## JOINT REGIONAL PLANNING PANEL (Sydney West Region)

<b>JRPP No</b>	2015SYW046 - <b>ADDENDUM TO ASSESSMENT REPORT</b>
<b>Date</b>	23 March 2016
<b>DA No.</b>	DA/127/2015
<b>LGA</b>	Parramatta
<b>Proposed development</b>	Staged development involving the demolition of existing structures, tree removal and construction of 5 buildings containing a residential aged care facility and independent living units pursuant to State Environmental Planning Policy (Housing for Seniors or People with a Disability) 2004, a child care centre, ancillary services with associated basement car parking, drainage and landscaping works.
<b>Street address</b>	2-6 Helen Street and 17 Park Avenue, Westmead
<b>Property Description</b>	Lot 51 DP 633455 and Lot 50 DP 633455
<b>Applicant</b>	Uniting Care Ageing
<b>Owner</b>	Uniting Care Ageing
<b>Recommendation</b>	Approval
<b>Report by</b>	Denise Fernandez, Senior Development Assessment Officer

**View from Caroline Street**

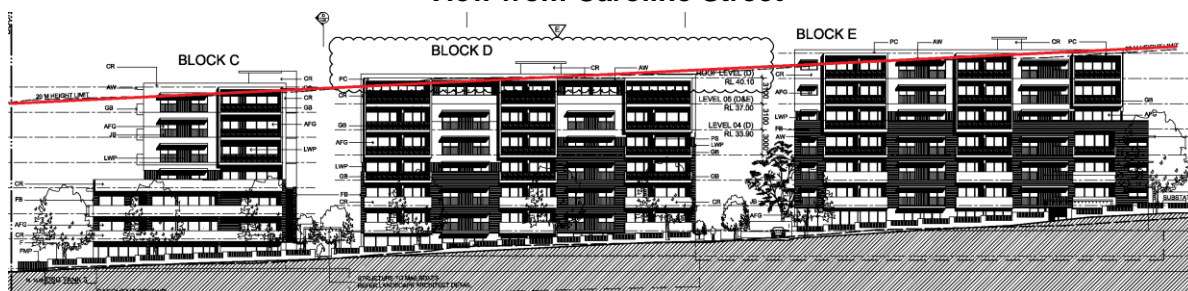
Maximum height under PLEP 2011	Proposed Building Height	Degree of variation and merit
<b>20 metres</b>	Block A – 24.85 metres	4.85 metres (or 24.25% from development standard)
	Block B – 23.085 metres	3.085 metres (or 15.4% from development standard)
	Block C – 23.05 metres	3.05 metres (or 15.2% from development standard)
	Block D – 22 metres	2 metres (or 10% from the development standard)
	Block E – 22.85 metres	2.85 metres (or 14.25% from the development standard)

A request for an exception under clause 4.6 was lodged with the amended application as the proposed height for Block D (as amended) still exceeds the maximum height for the site permitted by Clause 4.3 - Height. The applicant provides the following reasons to support the departure.
